Proposal for Parallel SCSI: Increase Transfer Rate and Improve Error Detection

To: T10 Technical committee
From: Jim McGrath
 Quantum Corporation
 500 McCarthy Boulevard
 Milpitas, CA USA 95035
 Phone: 408-894-4019
 Fax: 408-952-3620
 Email: jim.mcgrath@quantum.com
Date: September 15, 1998

Rev 6

Figure xxx: Fields within a Data Group

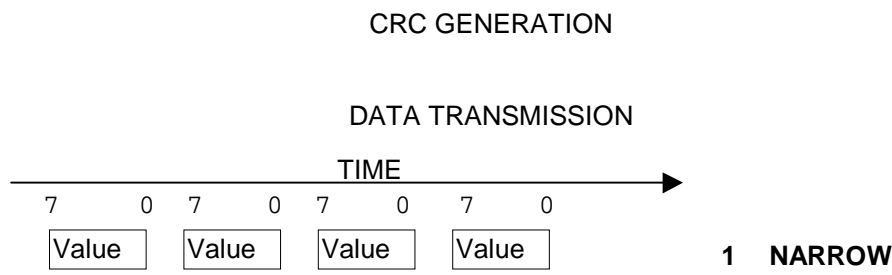
[Editors note: please change the above diagram to note that the pad bytes field is 0 or 2 bytes, not 0 to 3 bytes.]

WIDE BUS

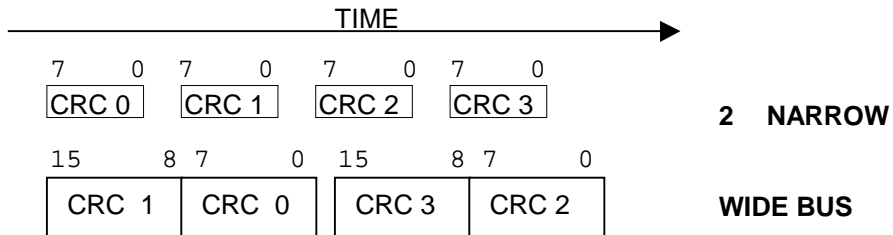
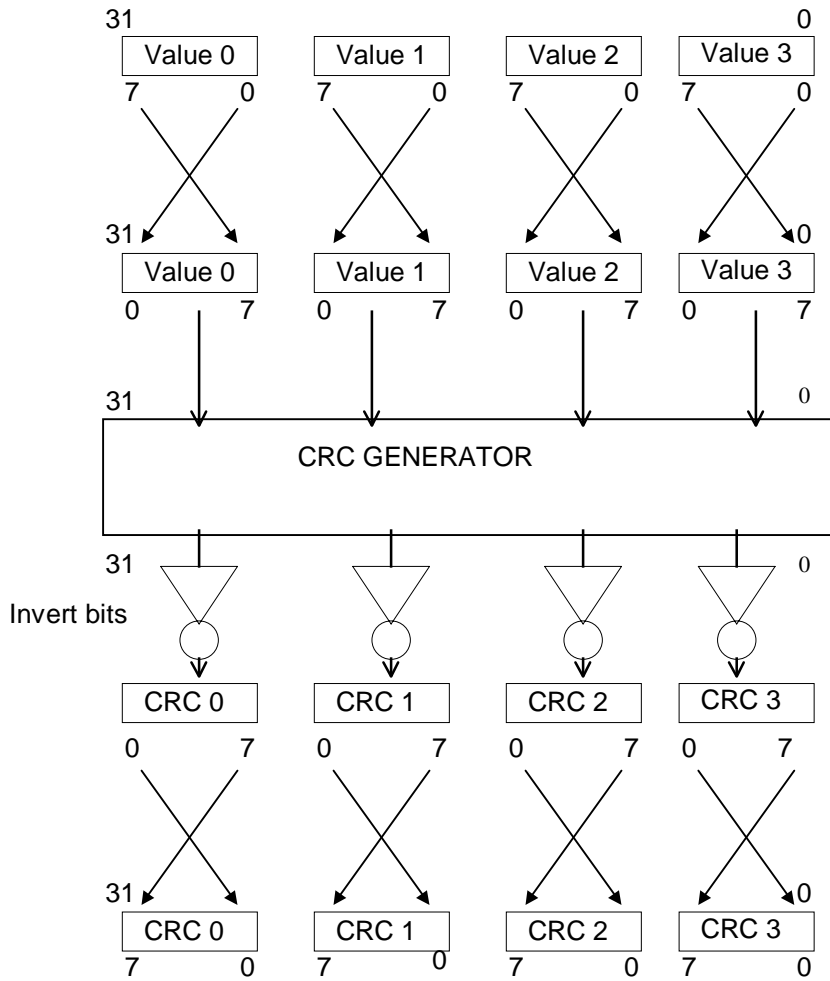
[Editors note: please change the above diagram to remove the narrow bus.]

Figure 2 -- CRC_AVAILABLE timing

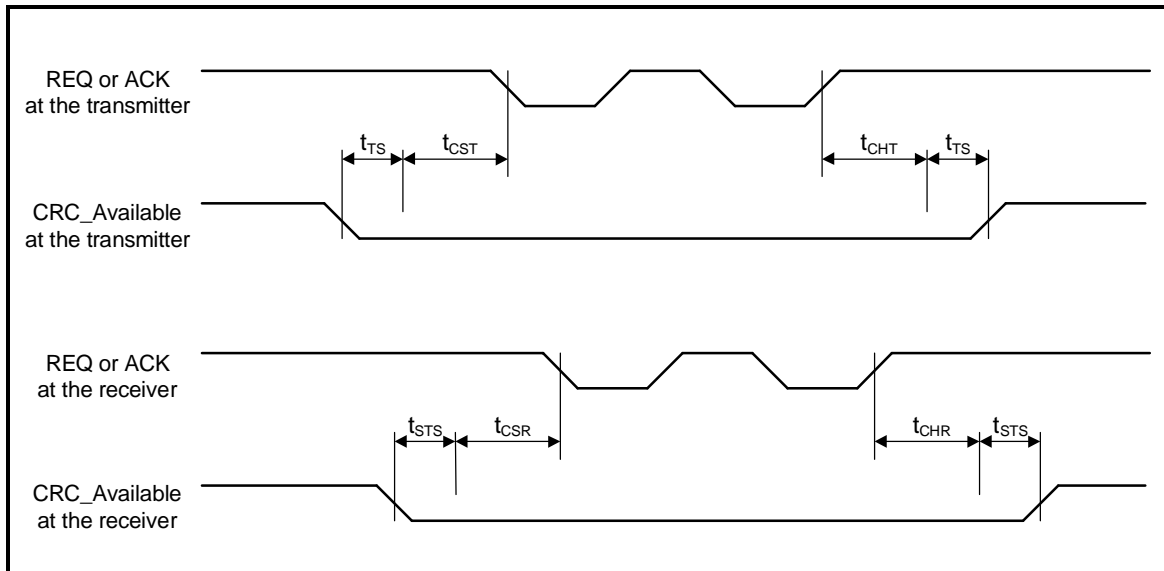
[Note: in the second t_{STS} , there should be additional setup time to allow CRC_AVAILABLE to transition. Following the precedence for setup to CRC_AVAILABLE, it is suggested that an extra 10 ns setup be added here. – CC_AVAILABLE setup time is 10 ns additional on either assert or deassert with request to REQ.]
